**RFP Title: Site Improvements at Roger Williams Park Event Pavilion**

**Addendum #: 1**

**Issue Date: 01/23/2024**

The purpose of this addendum is to extend the bid opening and answer questions from the Pre-Bid meeting.

# GRADING & MATERIALS PLAN

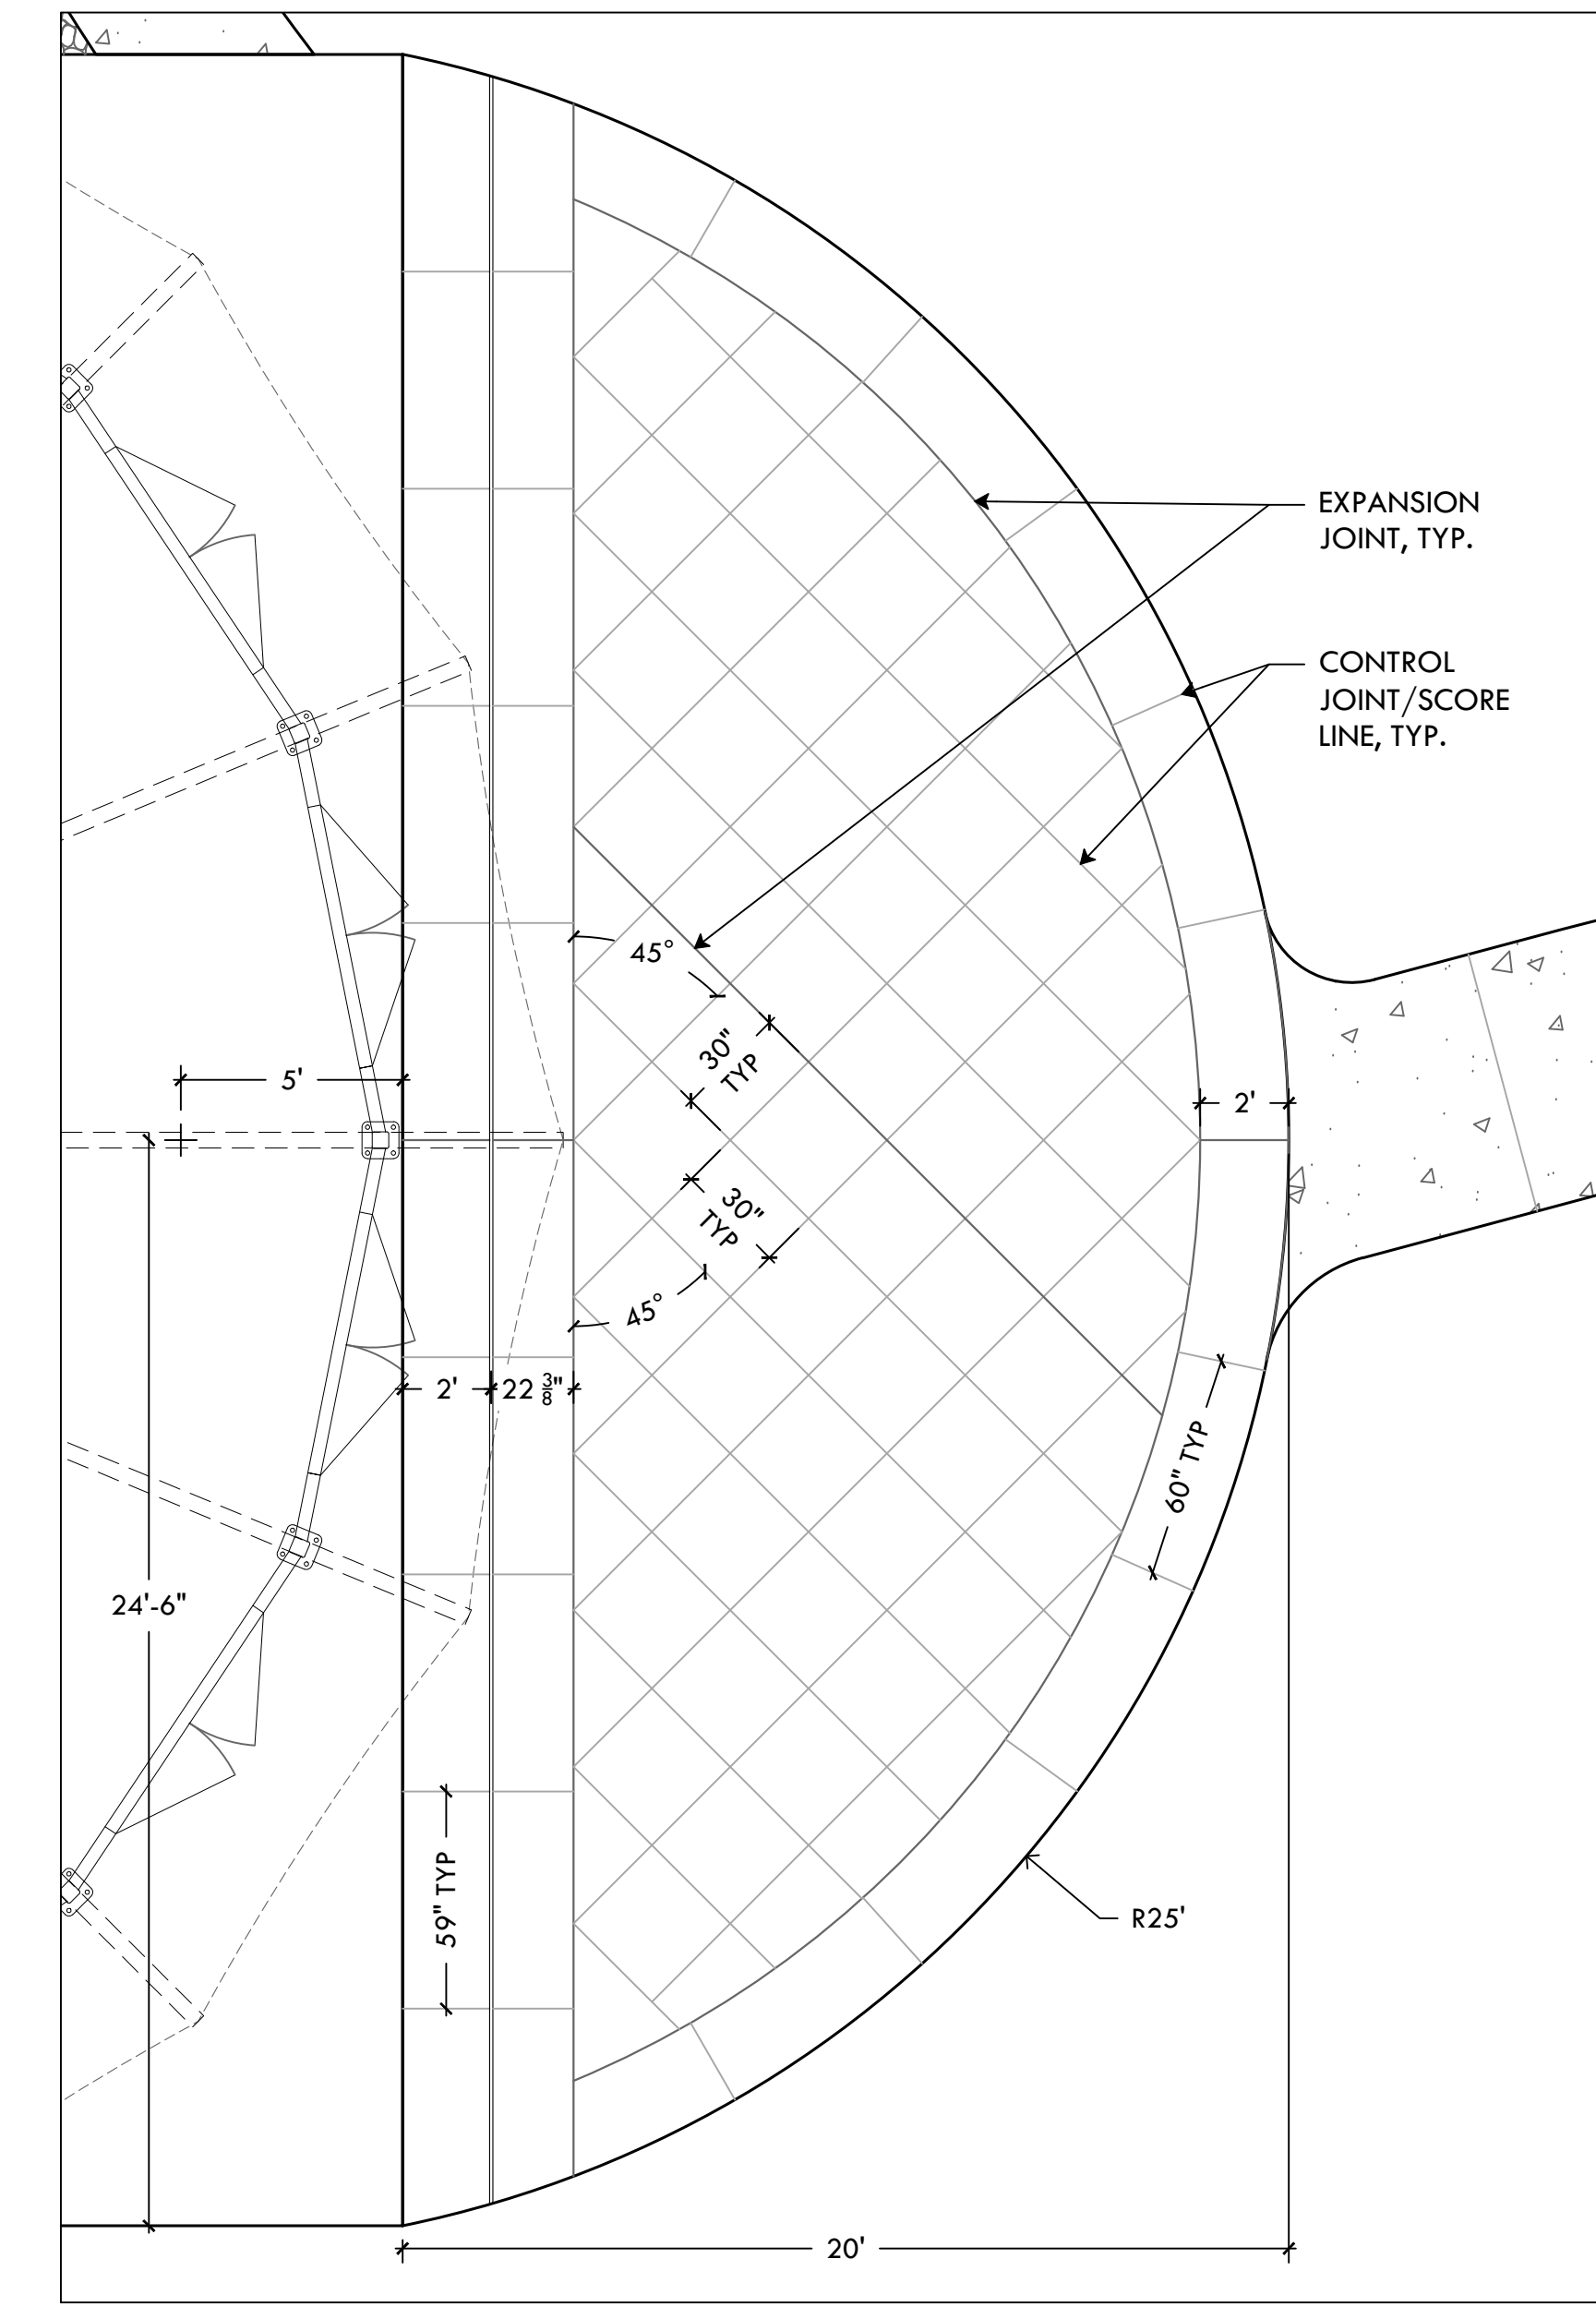
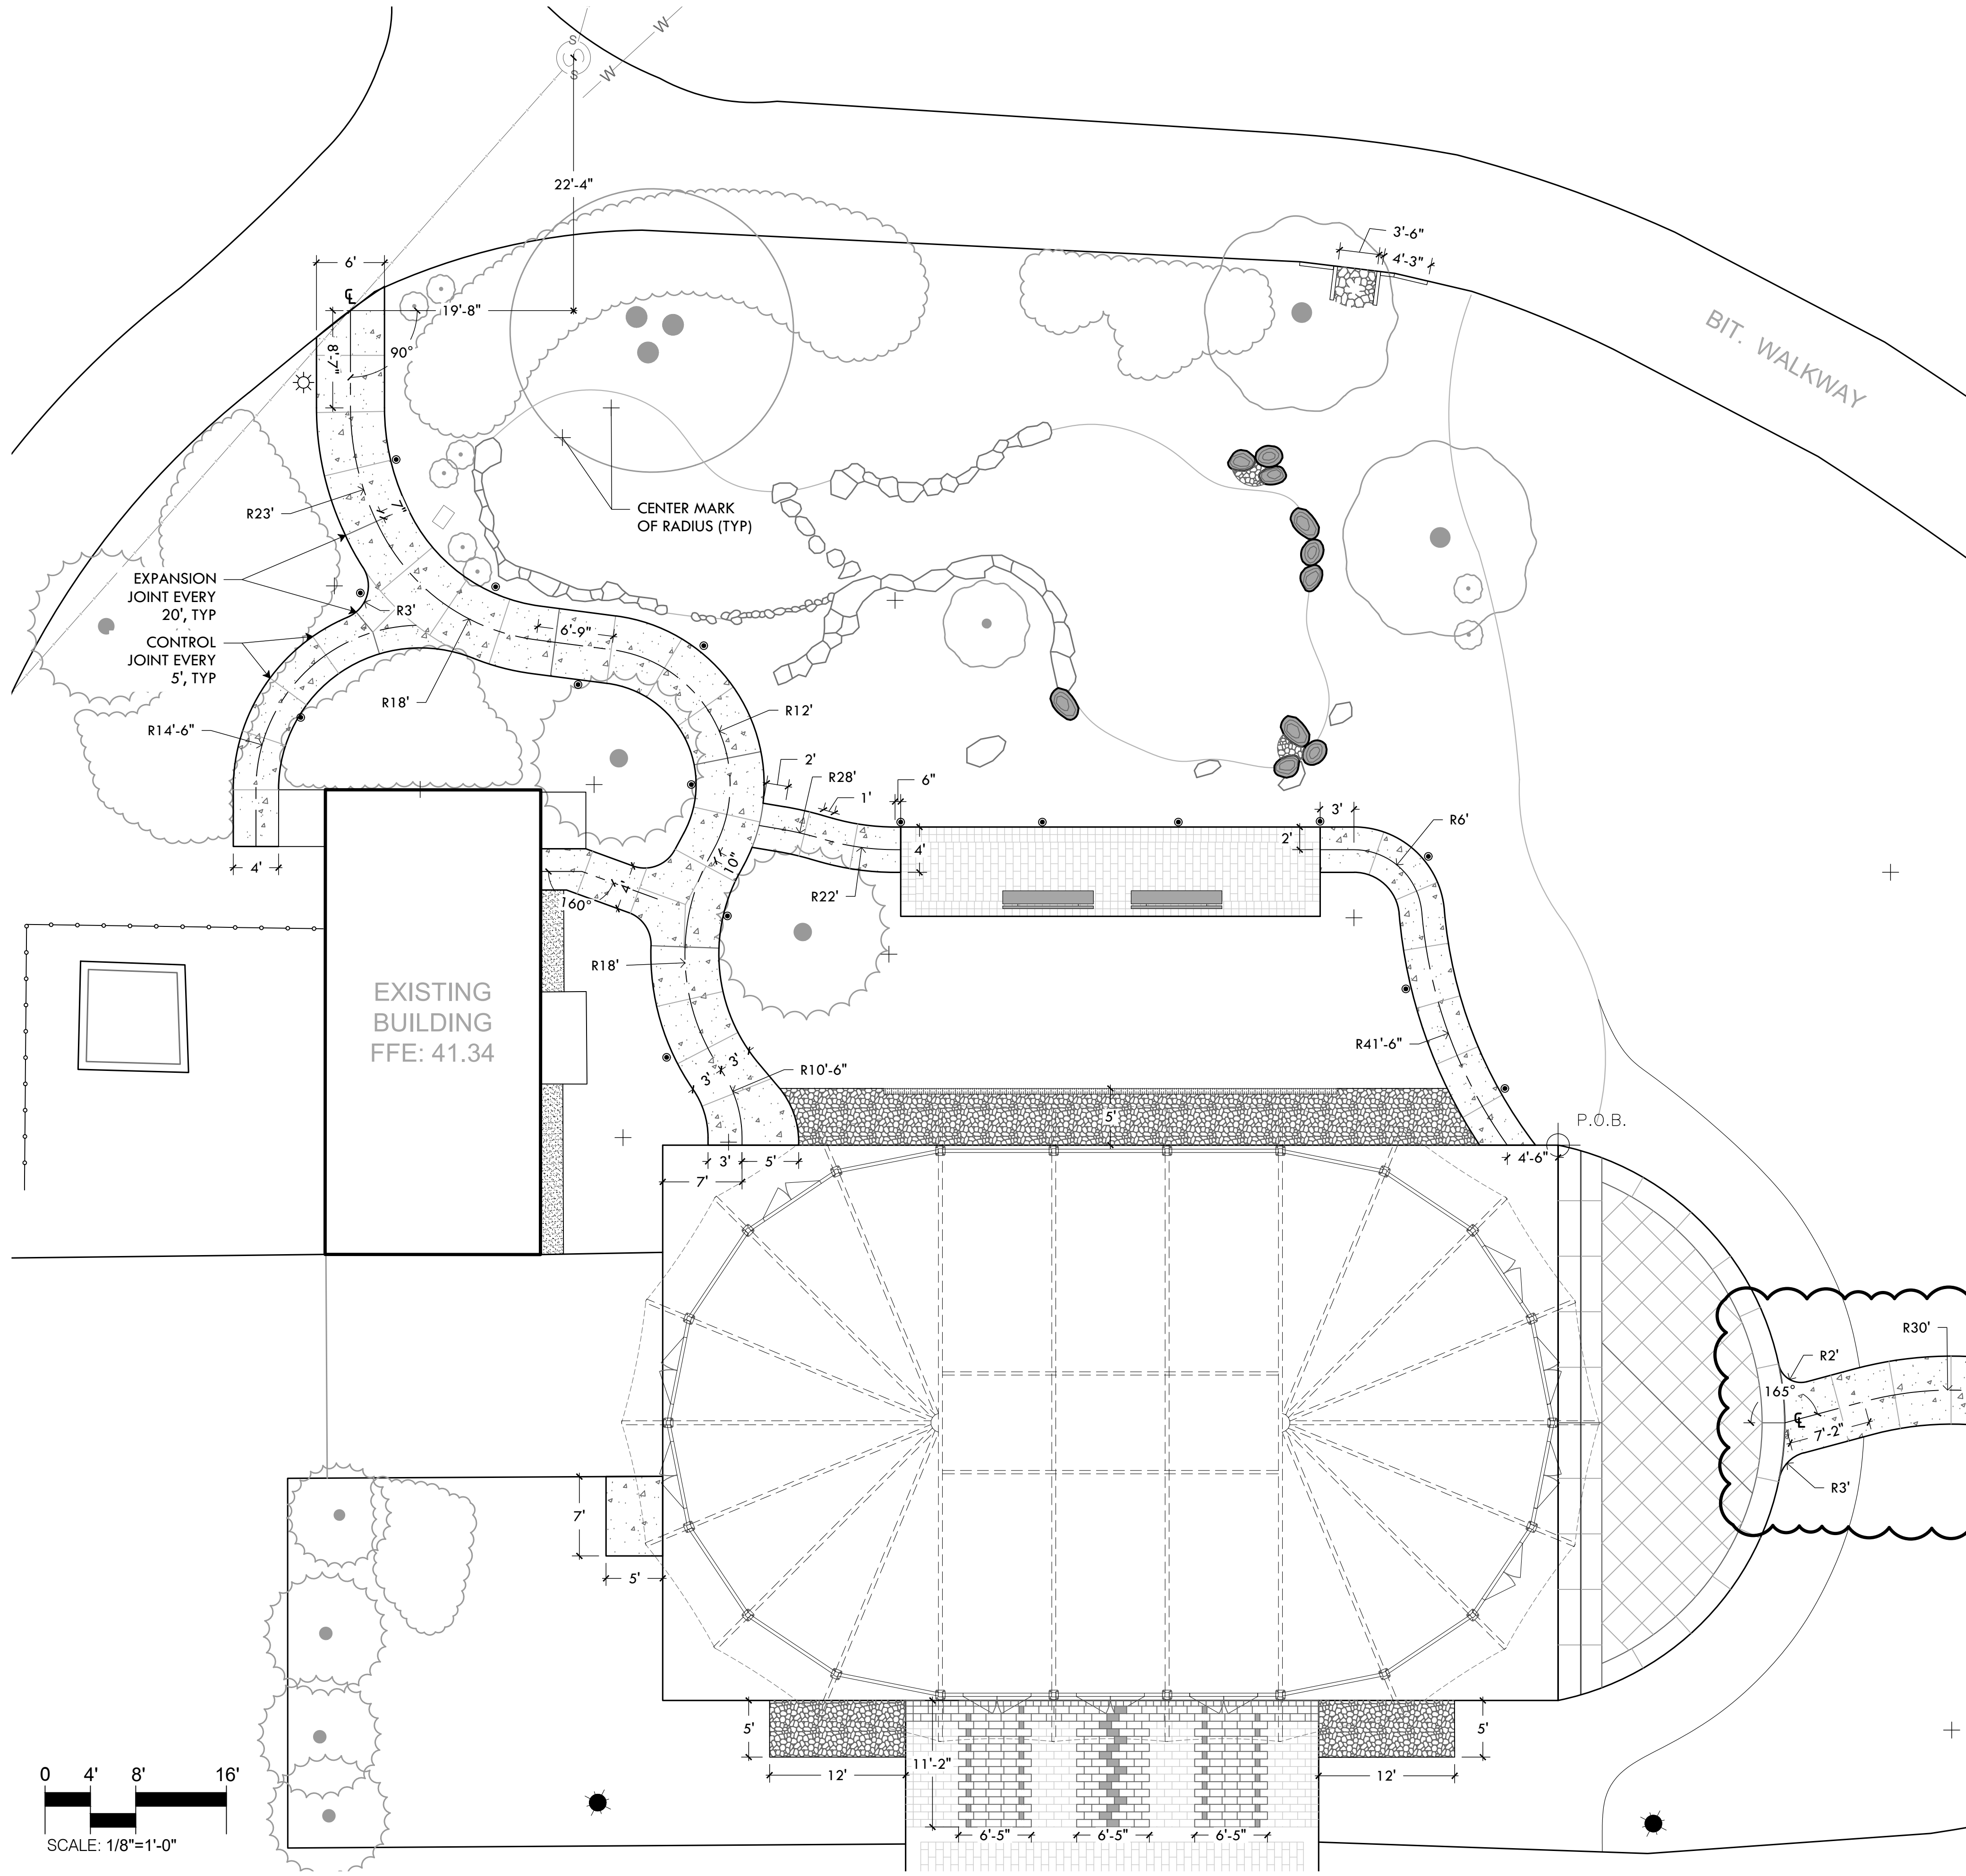
7. *Q: For the base bid, is your intent that the surfaces related to add alternates: plant beds, concrete and river stone areas be treated as lawn areas for the base scope?*

**See updated sheet L-3/L-6 for additional clarification.**
